MARY'S PLACE SUBDIVISION

APPLICATION NUMBER 6 DATE September 5, 2013
 APPLICANT Mary's Place Subdivision
 REQUEST Subdivision

DETAIL SITE PLAN

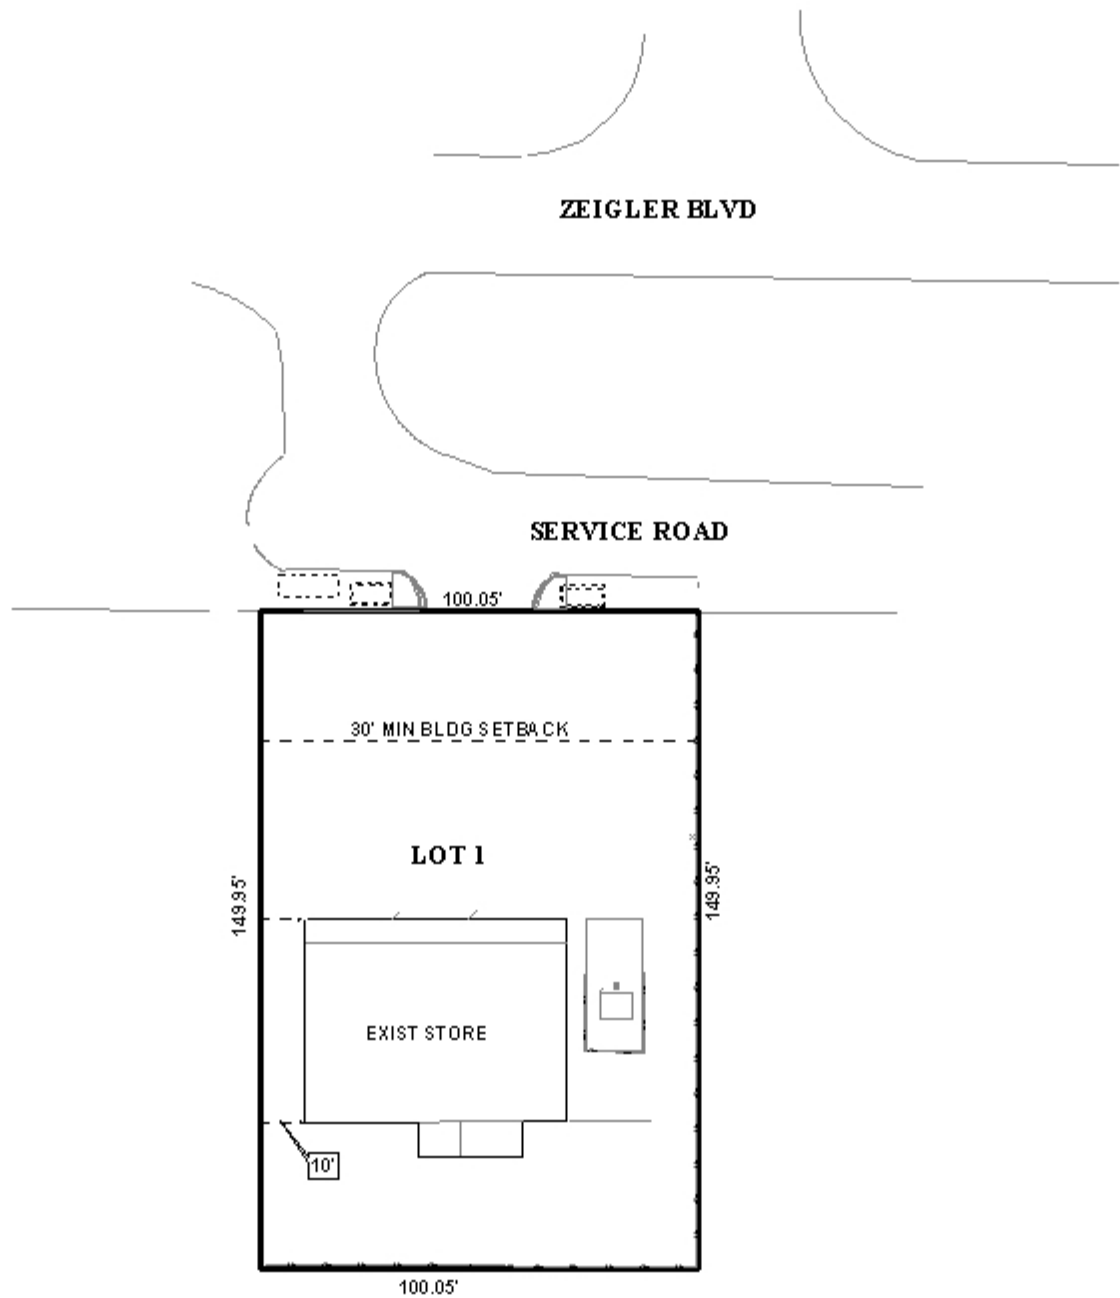
The purpose of this application is to create a legal lot of record from one metes and bounds parcel in order to satisfy a condition of approval for the site granted at the Planning Commission's January 3, 2013 meeting. The lot size is not labeled; however, the proposed lot would exceed the minimum size requirements of Section V.D.2. of the Subdivision Regulations. The lot size should be labeled in square feet and acres on the Final Plat, if approved.

The site fronts onto Zeigler Boulevard Service Road, a major street as illustrated on the Major Street Component of the Comprehensive Plan with a 100' right-of-way required. It should be noted that the existing right-of-way width at this location appears to be at least 180', due to the previous requirement of service roads along Zeigler Boulevard in past years. The preliminary plat does not indicate the right-of-way width at this location, and should be revised to label the minimum existing right-of-way width on the Final Plat.

The site plan illustrates a 30-foot building setback line, which exceeds the 25-foot minimum requirement in Section V.D.9. If approved, the building setback line should be retained on the Final Plat.

The site has 100'± linear feet of street frontage, and currently appears to have one curb cut. As a means of access management, the lot should be limited to the existing curb cut, with the size, location and design of curb cuts to be approved by Traffic Engineering and conform to AASHTO standards.

- 1) retention of the 25' minimum building setback line along all street frontages;
- 2) labeling of the lot size in square feet and acres;
- 3) revision of the plat to accurately label the minimum existing right-of-way width;
